**SUBDIVISION COMMITTEE
METROPOLITAN AREA PLANNING COMMISSION**

**STAFF REPORT
(Preliminary Plat)**

CASE NUMBER: S/D 89-68 - BILL BAILEY 2ND ADDITION

Re: S/D 89-68 BILL BAILEY 2ND ADDITION

PRELIMINARY PLAT

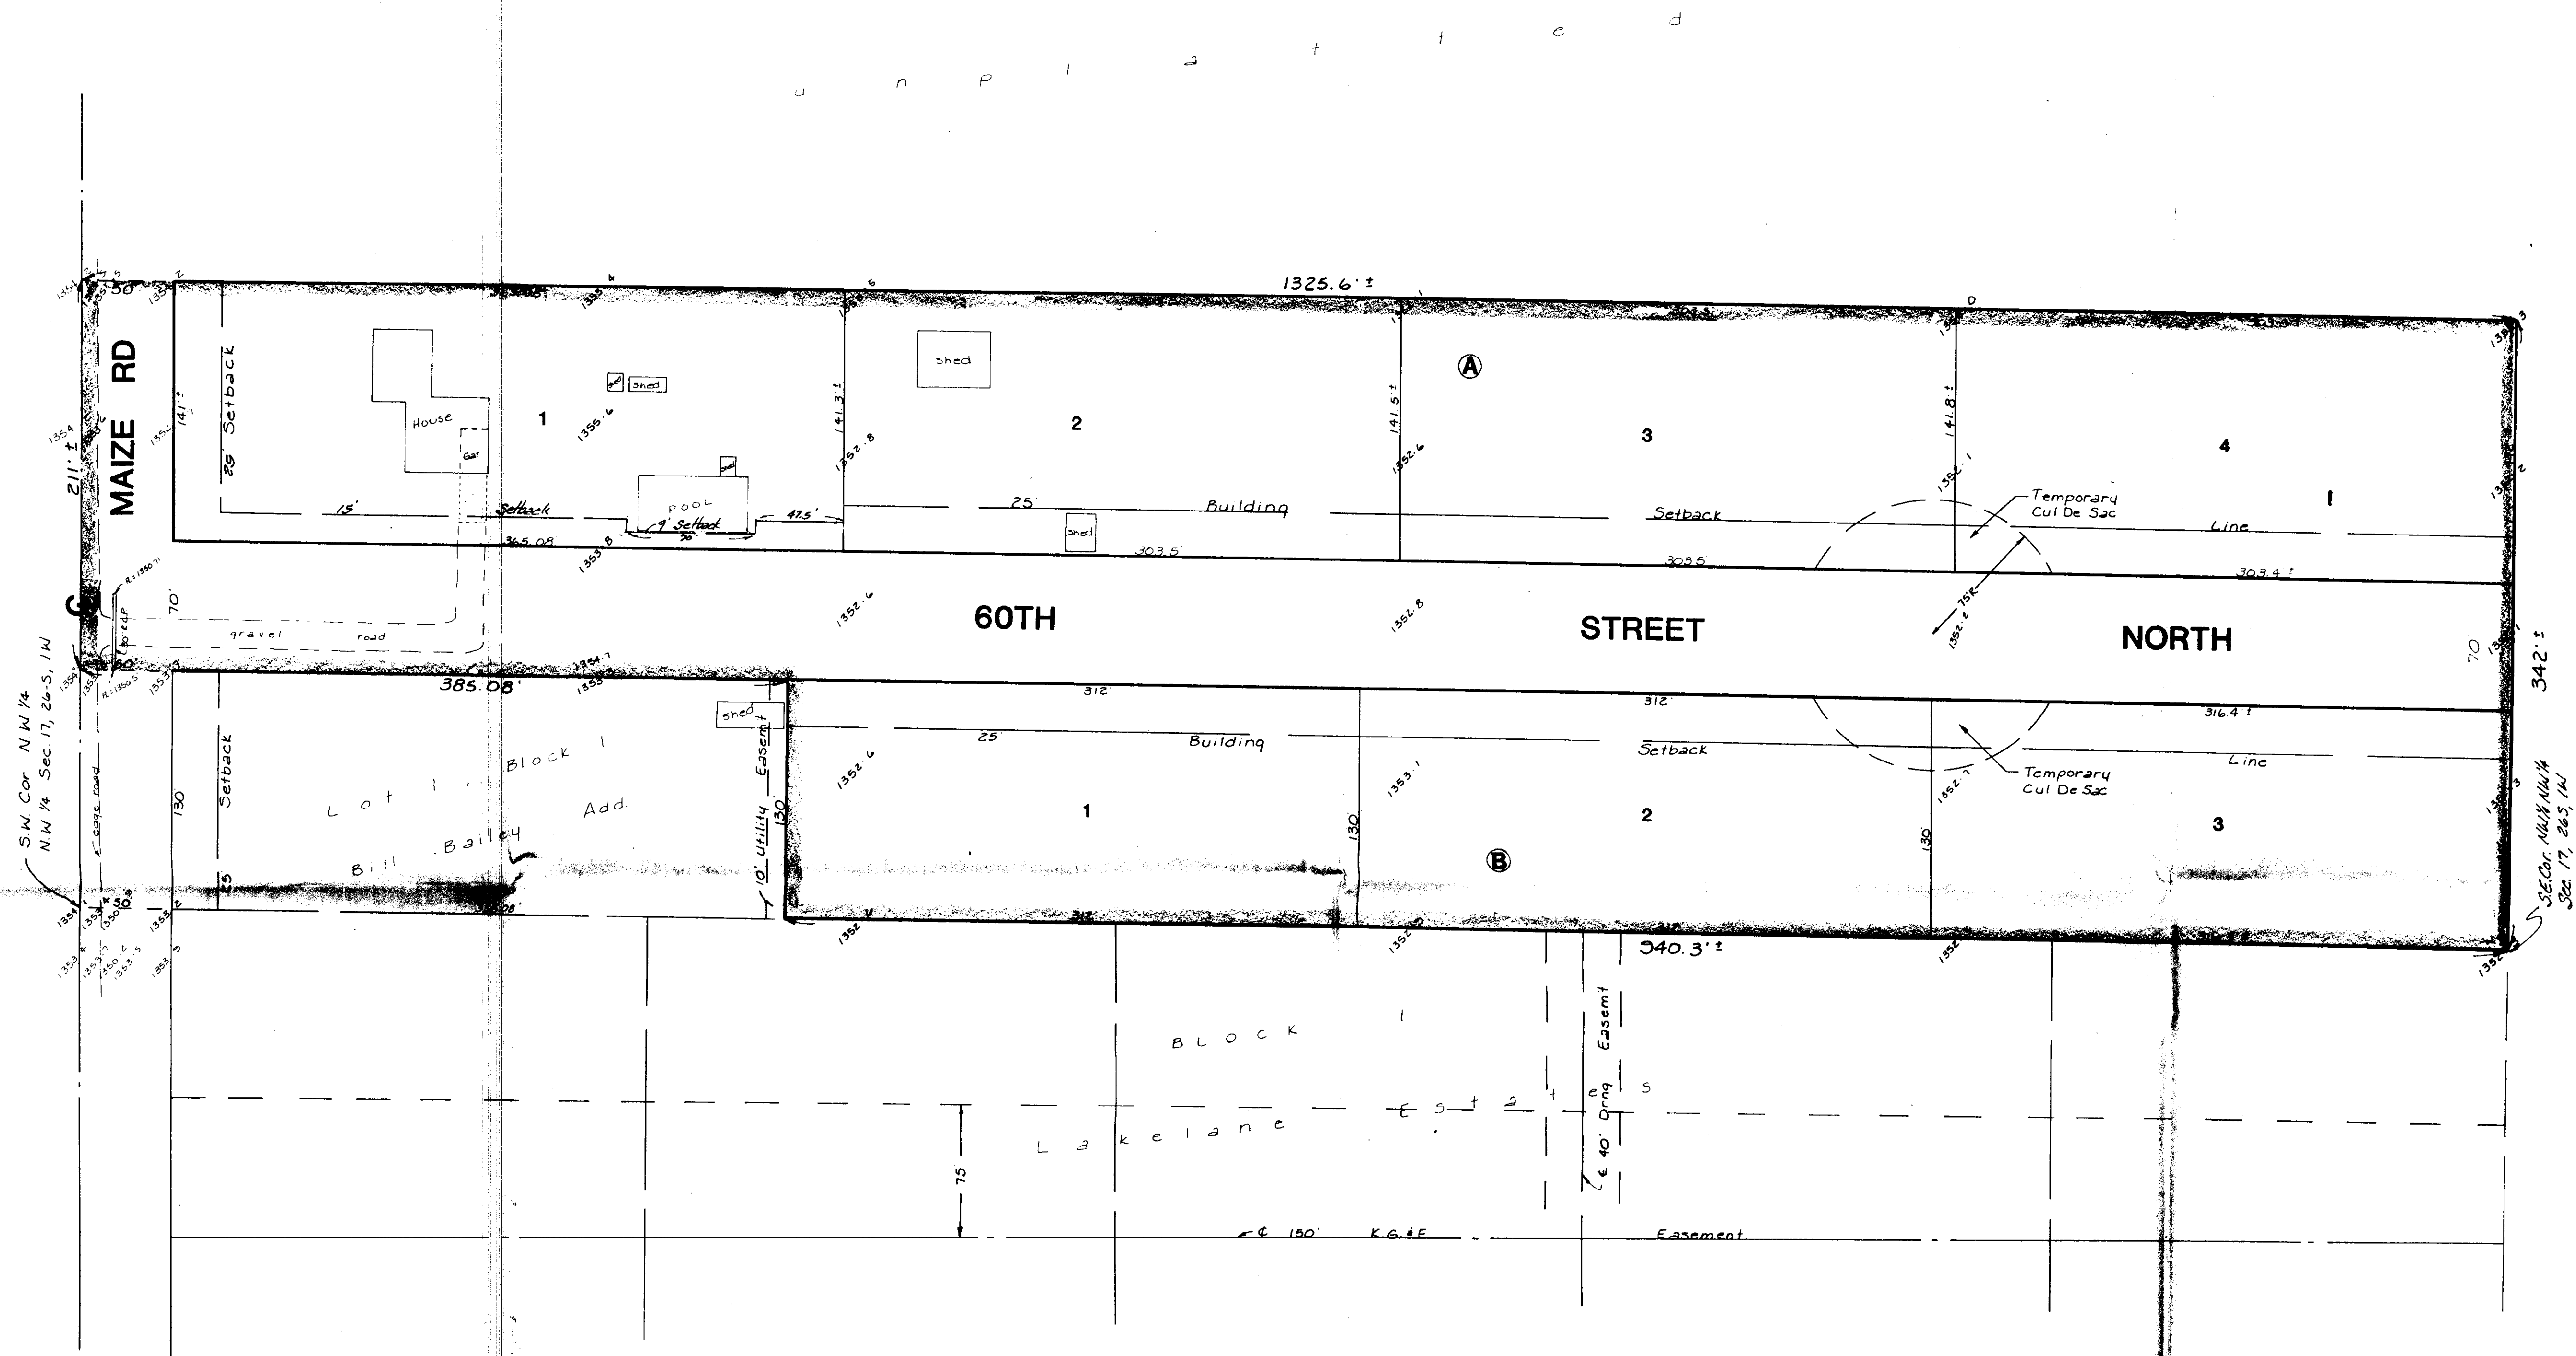
- E. On the final plat complete access control shall be indicated to Maize Road from the west line of Lot 1, Block A. The plat's text shall state that the access control is being dedicated to the County.

- F. Lot 1, Block B shall also establish a 25-foot building setback to 60th Street. As indicated above and by the sketch plat, access to this site is by way of the proposed street. This setback maybe jogged around the existing pool.

- G. On the final plat tracing the cul-de-sac shall be indicated as temporary and the platlor's text shall indicate that this temporary cul-de-sac will be vacated when 60th Street North is extended east.

- H. If required by the drainage plan, a floodway shall be indicated for this plat and the platlor's text shall reference the standard floodway language.

- I. As required by section 8-103(1), the final plat shall indicate the placement of irons at all corner's of this subdivision. A legend shall be added to the face of the plat which identifies the irons set and the irons found.
